DraftPreliminaryHRSC_CSM_FID_082416_TowerStandard.4dm - 4DIM Player
Author: Jason C. Ruf
Organization: S2C2 Inc.
Description: Draft CSM for High Resoluti...
Tower Standard Site
Lac du Flambeau, Wisconsin
Data Analysis and Data Visualization Report
August 2016
Vertical Exaggeration is 2.5x
MIP-FID above 50,000 uV
S2 C2 inc.
Elevation
Easting
1,990,400
1,990,500
1,990,600
1,990,700
25 ft/day
50 ft/day
MIP-FID
10,000,000 uV
3,000,000 uV
1,000,000 uV
300,000 uV
100,000 uV
30,000 uV
10,000 uV
Total VOCs
1,000,000 ug/kg
300,000 ug/kg
100,000 ug/kg
30,000 ug/kg
10,000 ug/kg
3,000 ug/kg
1,000 ug/kg
300 ug/kg
100 ug/kg
30 ug/kg
10 ug/kg
3 ug/kg
1 ug/kg
NOTES:
See Data Analysis and Data Visualization Report for data visualization details.
Inbox - Mailbox - Kady, Tom - Outlook
To... Egan, Robert
Subject RE: Recommendations for additional well locations at the Tower Standard site
Hi Bob – I've included below in red some of the logic and additional details from our discussion on the proposed monitoring well locations. I believe this information will help to provide some boundary conditions to improve the accuracy of the 3D data visualization and to help provide a reliable basis to quantify the

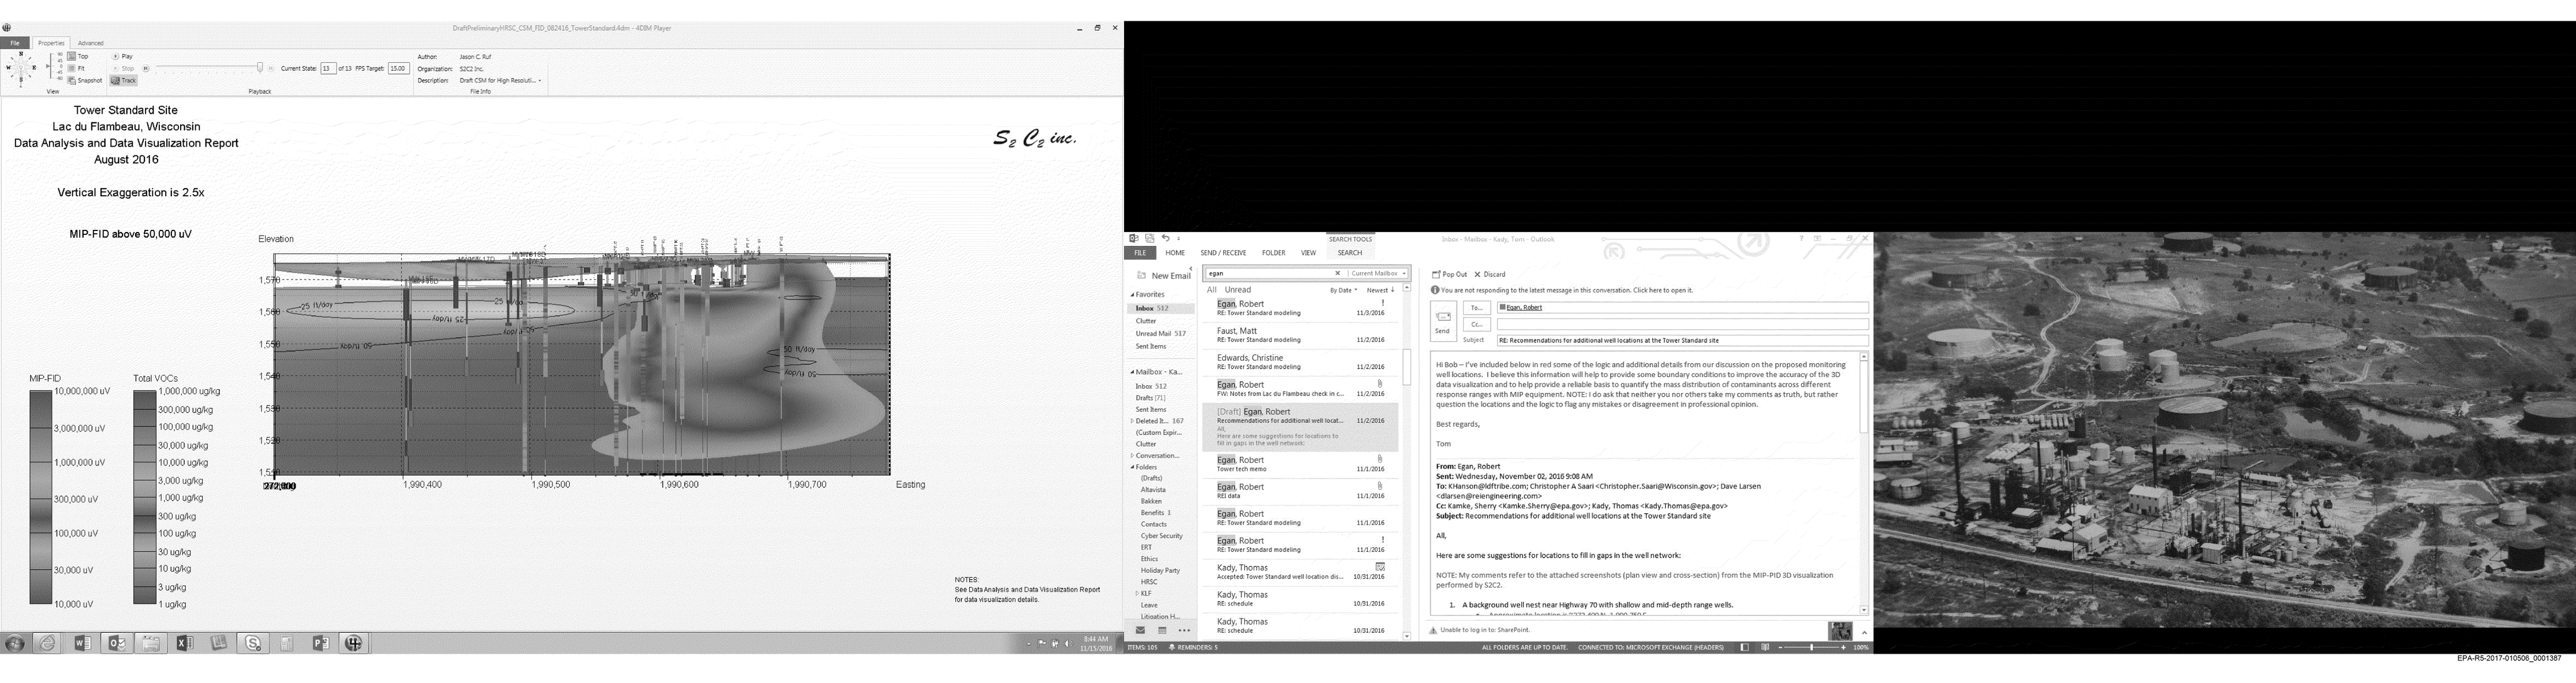
1. A background well nest near Highway 70 with shallow and mid-depth range wells.
8:44 AM
11/15/2016
